LA FOLLETTE PARK IMPROVEMENTS
CITY OF KAUKAUNA, OUTAGAMIE COUNTY, WI
OPTION A OVERVIEW

LAFOLLETTE PARK PAVILION
CONCEPT A

LAFOLLETTE PARK PAVILION
CONCEPT **B**

LAFOLLETTE PARK PAVILION
CONCEPTUAL RENDERING

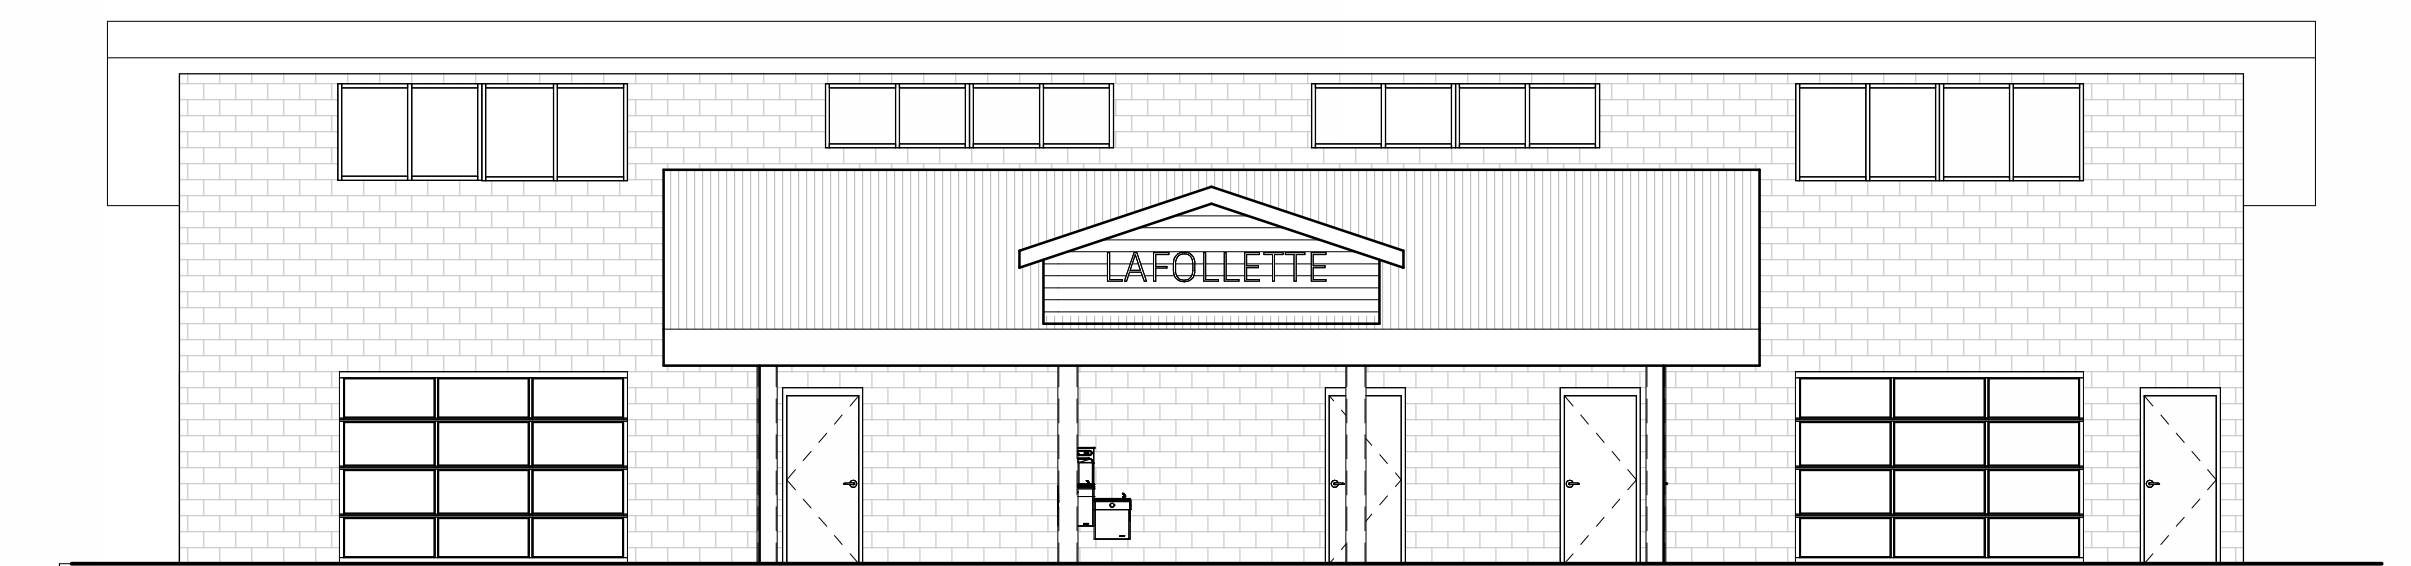
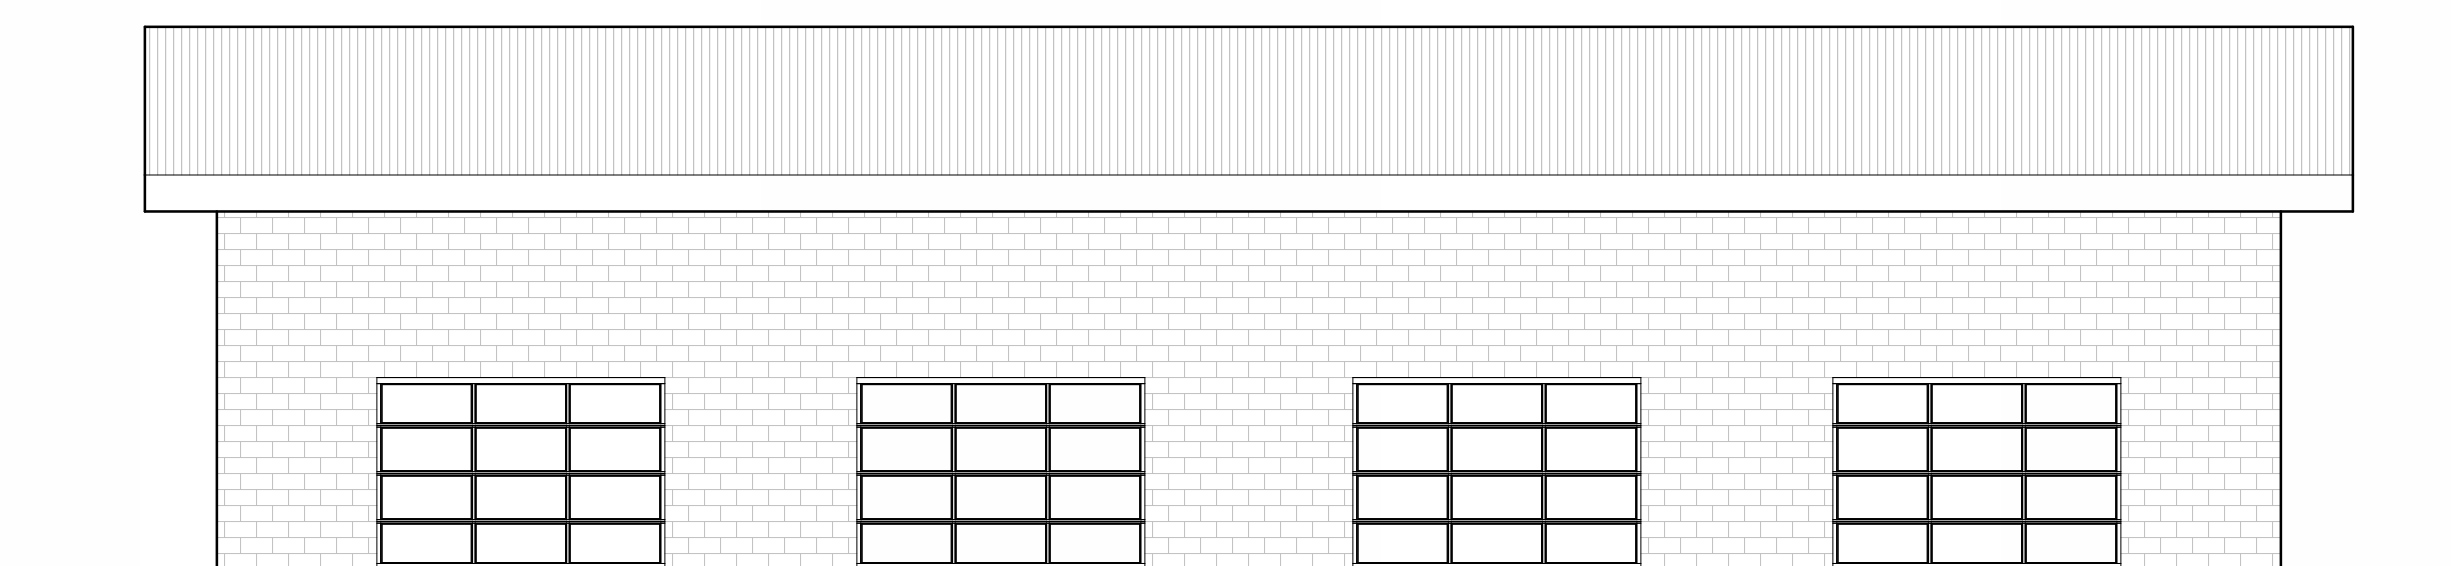
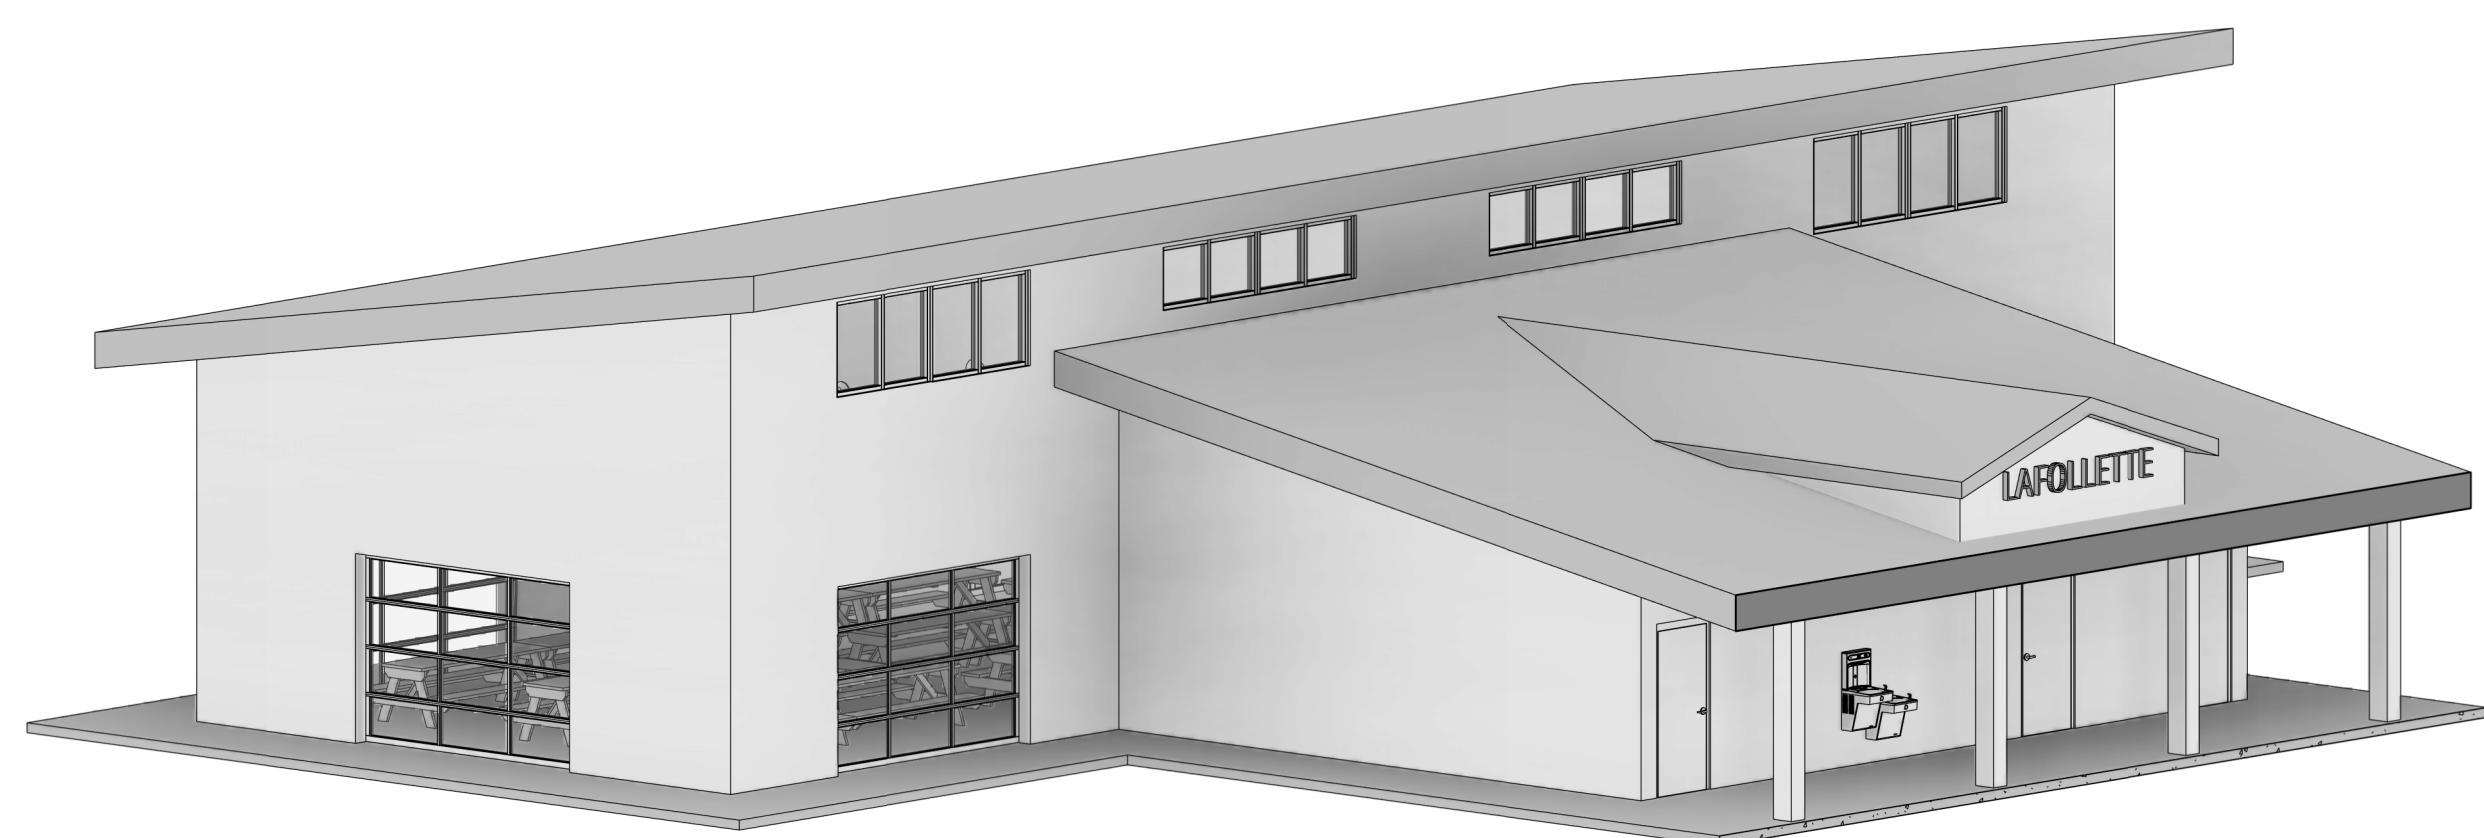
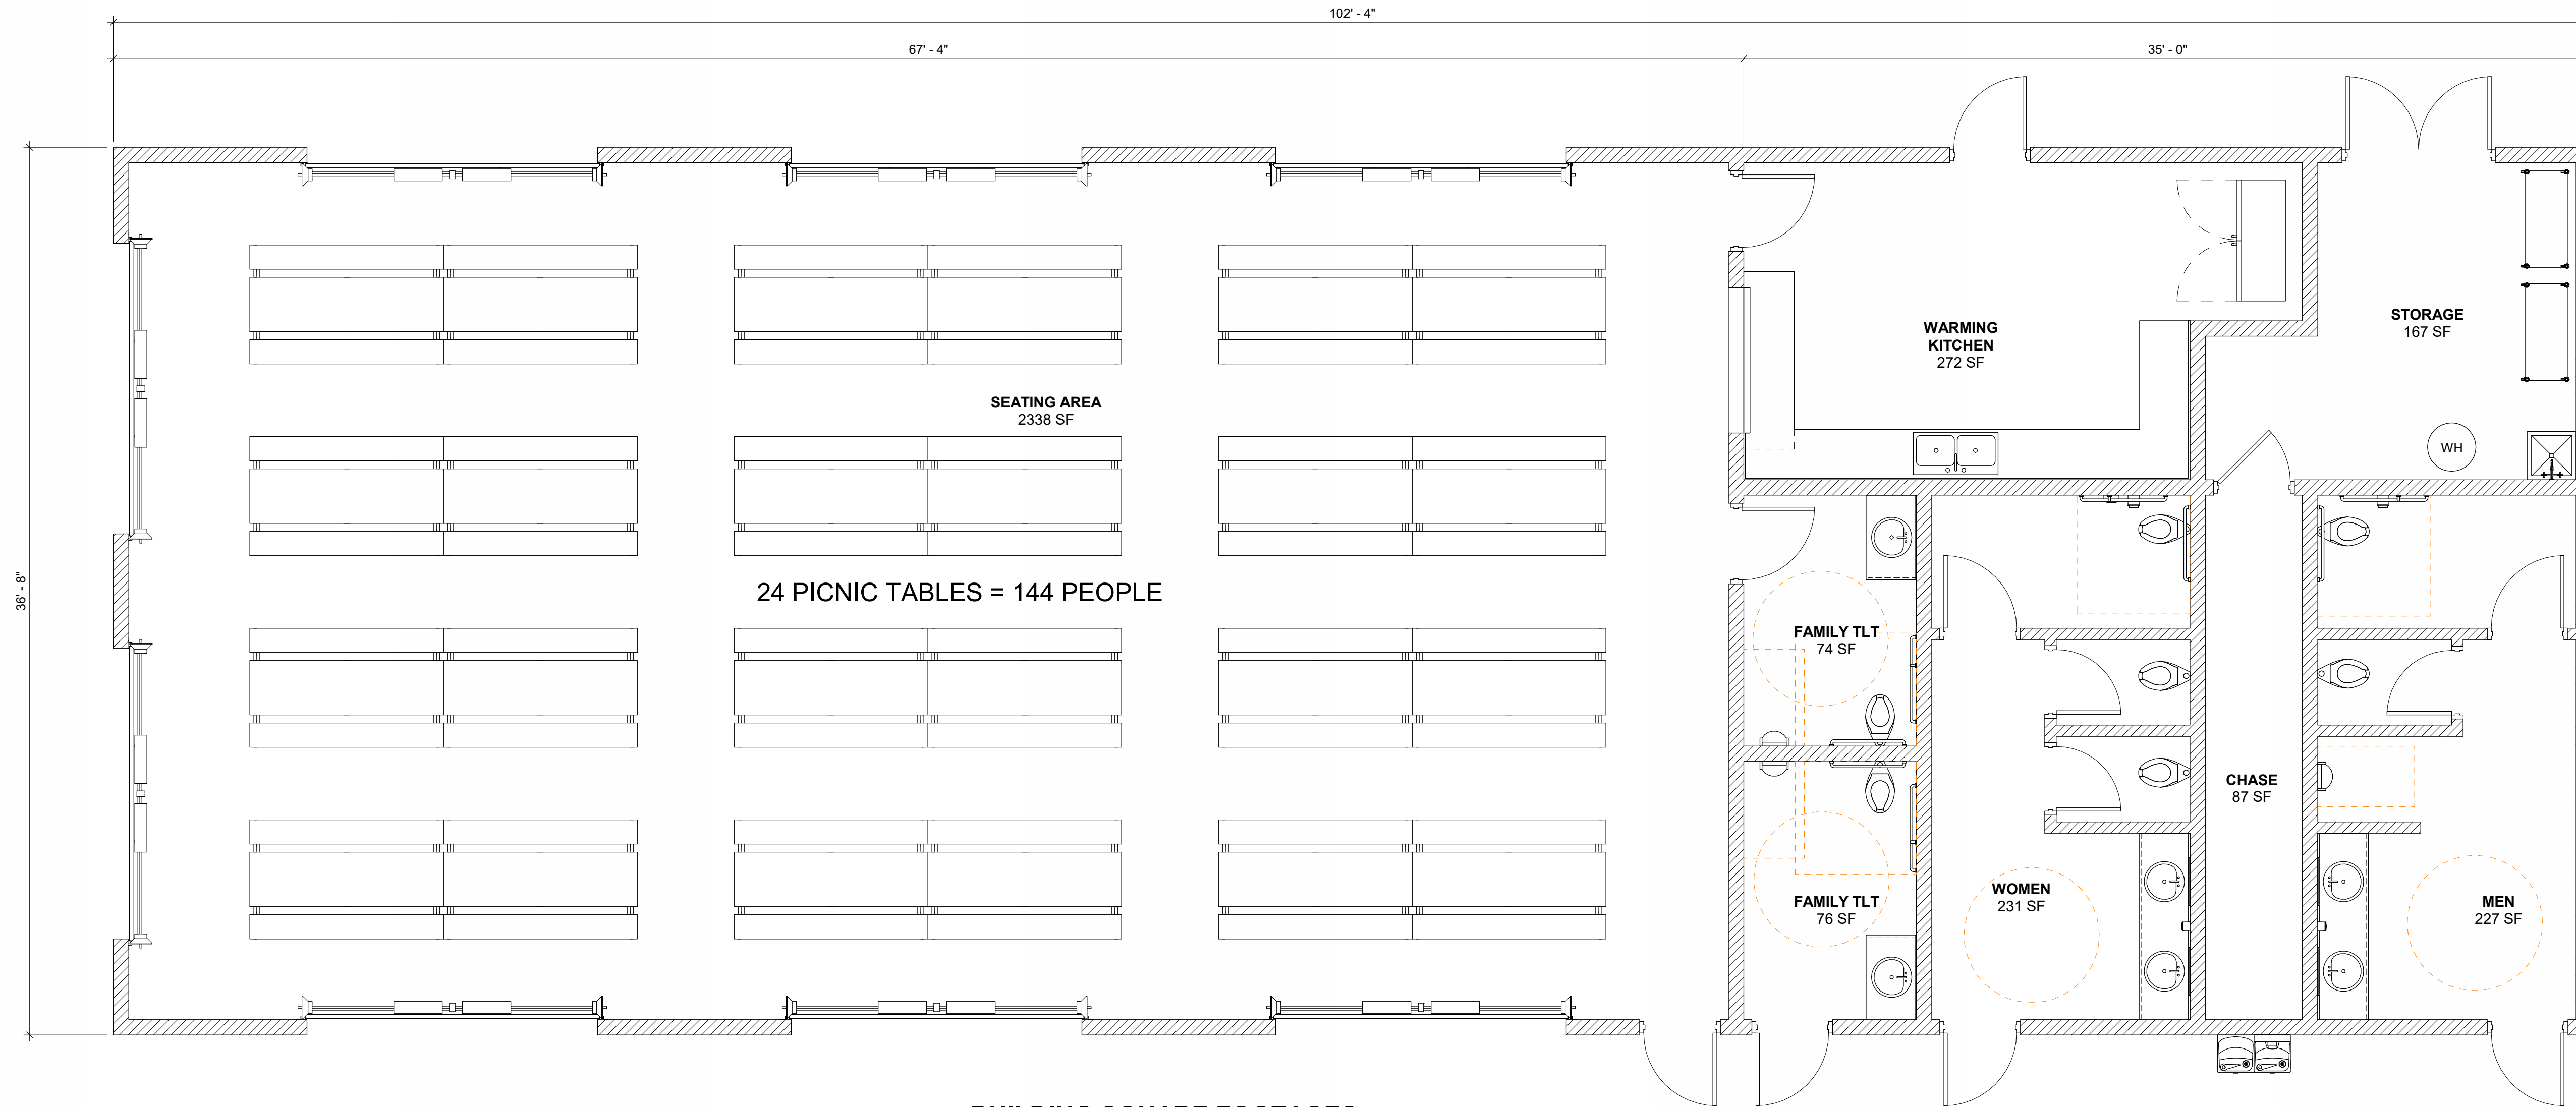
2. Do you have additional feedback for Concept A?

"I don't like how the pavilion is all in the back. Kids sometim... "

A word cloud containing the following terms: tick in cost, smaller facilities, maintenance cost, large Pavillion, park, picnic table, park in Kaukauna, open look, park pavilion, windows, Handicapped restrooms, use, higher cost, table layout, Horseshoe park, cost needs, table area, electrical system, and finally going.

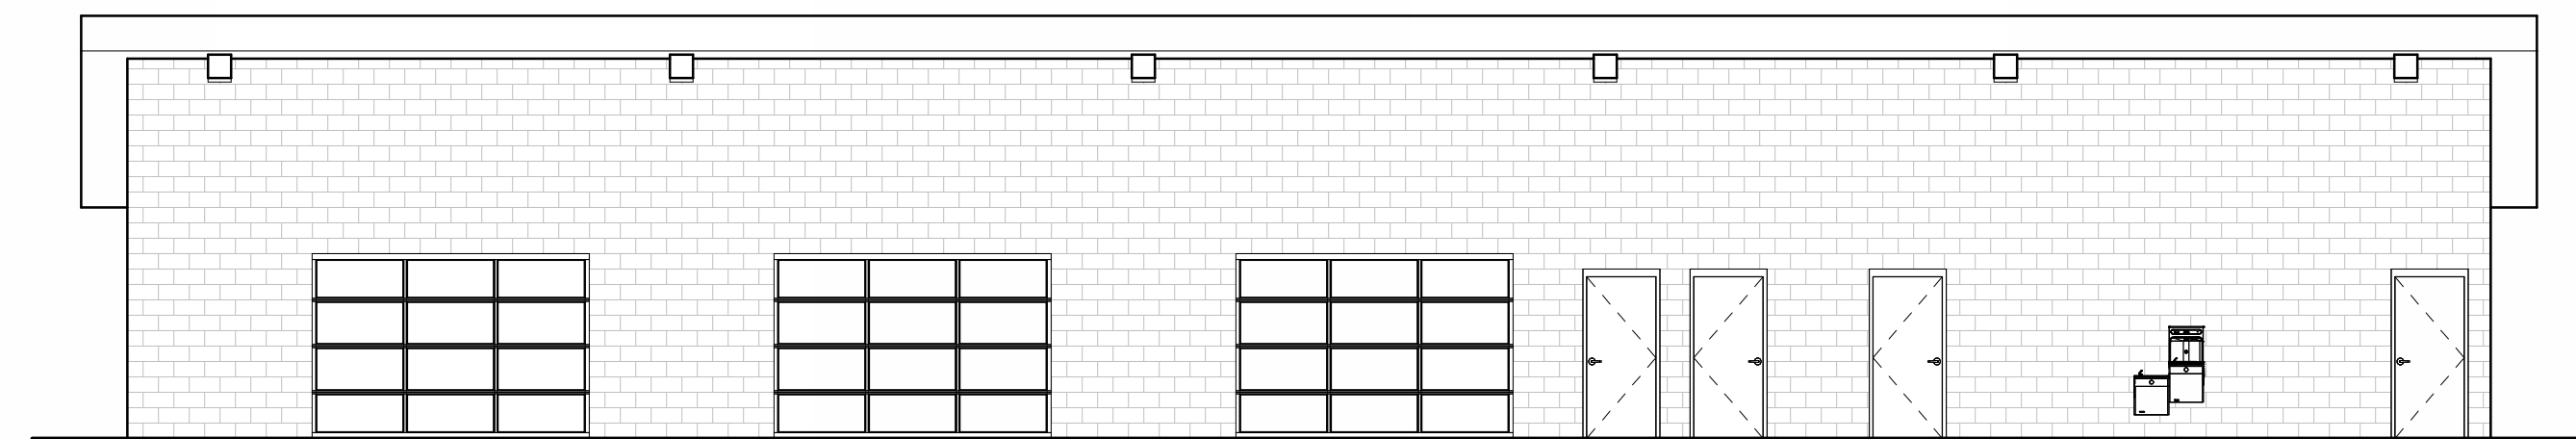
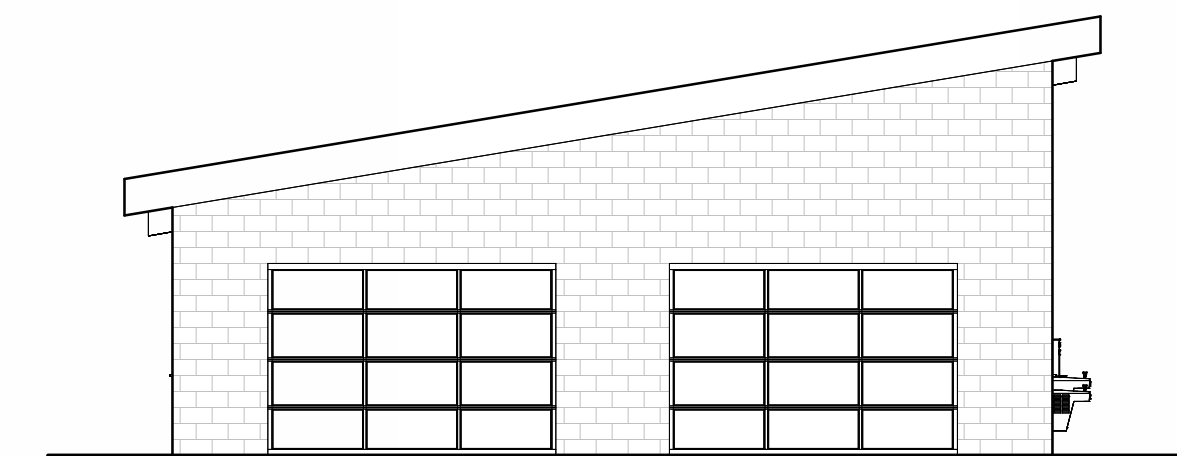
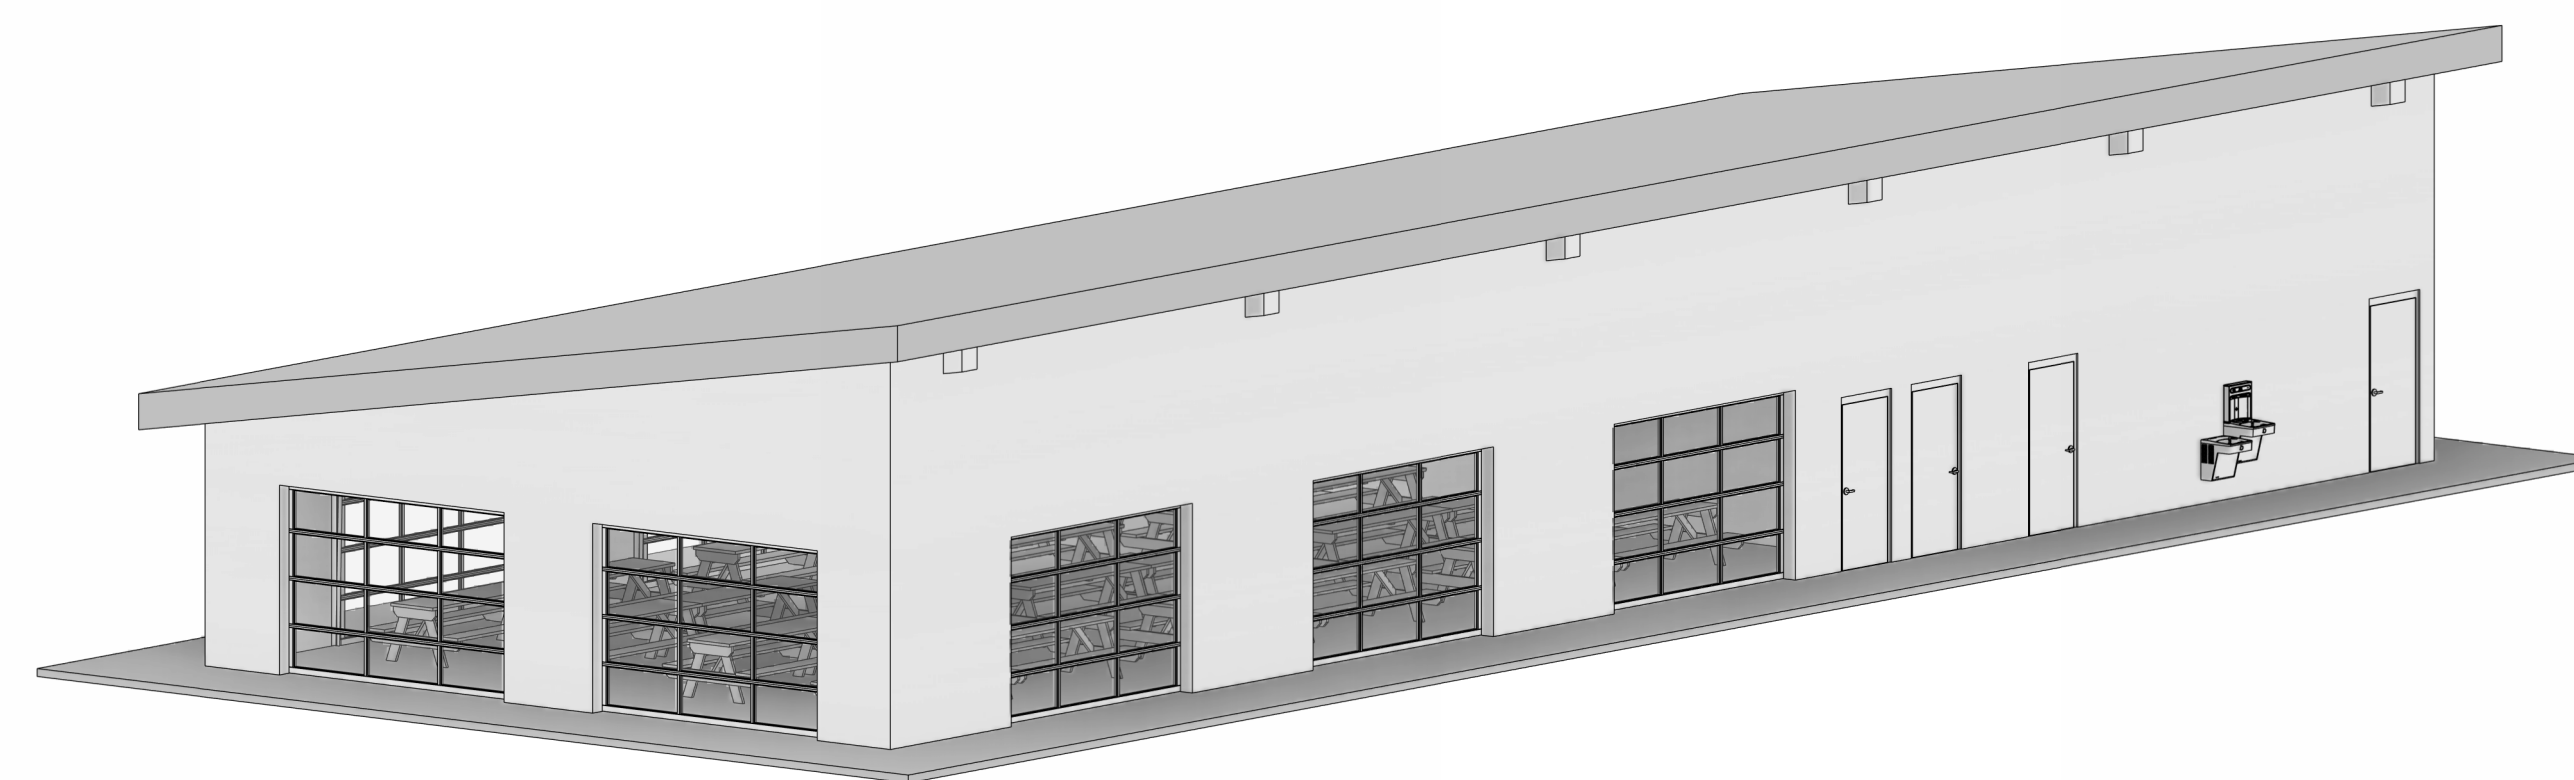
3. Do you have additional feedback for Concept B?

"Put "LaFollette Park" lettering on the front like Concept A."

A word cloud containing the following terms: facilities, windows, use of space, flat, closer, cost solution, area in this concept, option for the build, taxes, handwashing and restroom, shed roof, warehouse, foot print, cost option, lower, distance for kids, LaFollette Park, and vibes.
